| Project | IEEE 802.16 Broadband Wireless Access Working Group < http://ieee802.org/16 > |
| Title | Offset indicator for reliable H-ARQ Compact MAP message |
| Re: | This is a response to a Call for Comments on IEEE P802.16e-D5a |
| Abstract | Enhancement to the H-ARQ Compact MAP message transfers by defining Start Offset and ACK Offset |

Figure 1. The methods of H-ARQ Burst allocation and ACK channel allocation

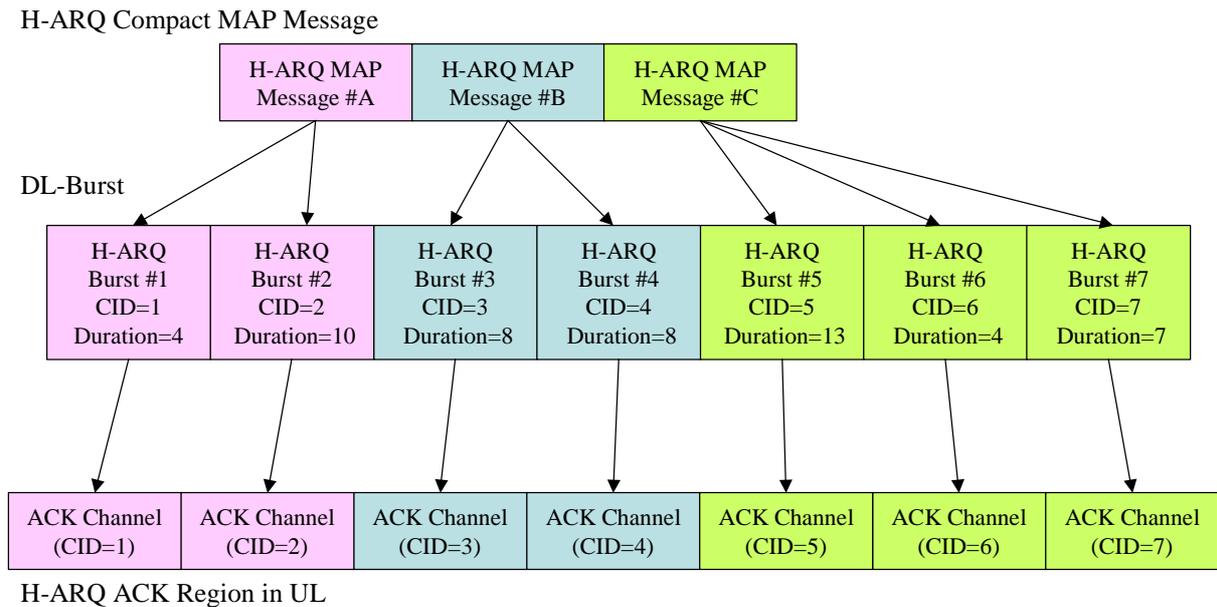
In OFDMA of the current 802.16e standard/D5a, an MSS shall read H-ARQ compact MAP messages transferred to another MSS in order to know the exact location of the burst allocated in DL and ACK channel in ACK Region of UL by calculating the whole sum of burst durations and the sum of bursts number in the previous H-ARQ compact MAP messages. However, when an MSS allocated in the second H-ARQ compact MAP message cannot decode the first H-ARQ compact MAP message, it cannot be informed of the exact location of allocated burst in H-ARQ compact MAP message in DL and ACK channel in ACK Region of UL where each MSS shall respond.

For instance, if MSS#3 has a CID of 3 in H-ARQ compact MAP message #B and it fails to decode H-ARQ compact Map message #A indicating burst #1 and #2, MSS#3 does not know the number and duration of each burst in H-ARQ compact MAP message #A so that it cannot calculate sum of burst durations and burst numbers. As a result, the MSS#3 cannot determine the exact location of burst and ACK channel that the MSS #3 shall use. For an another instance, MSS #5 whose CID is supposed to be 5 in H-ARQ compact MAP message #C fails to decode H-ARQ compact Map message #A, it will experience the same problem explained above. Even if MSS #5 succeeds in decoding HARQ compact MAP message #B, it cannot determine the exact location of burst and ACK channel that it shall respond. Consequently, BS shall retransmit H-ARQ bursts to each MSS, which leads to overhead of radio resource.

In this contribution, we propose Start Offset and ACK Offset. The Start Offset indicates the start location of burst in DL, which is mapped to the first burst in each H-ARQ compact MAP message. And ACK Offset indicates the start location of ACK Channel in H-ARQ ACK Region explicitly, which is mapped to the first burst in each H-ARQ compact MAP message. Both the Start Offset and ACK Offset information are included in the Compact DL-MAP IE as shown in Table XXx. The remedy is to use a new Compact DL-MAP Subtypes IE under the existing 'extension' type of Compact DL-MAP IE.
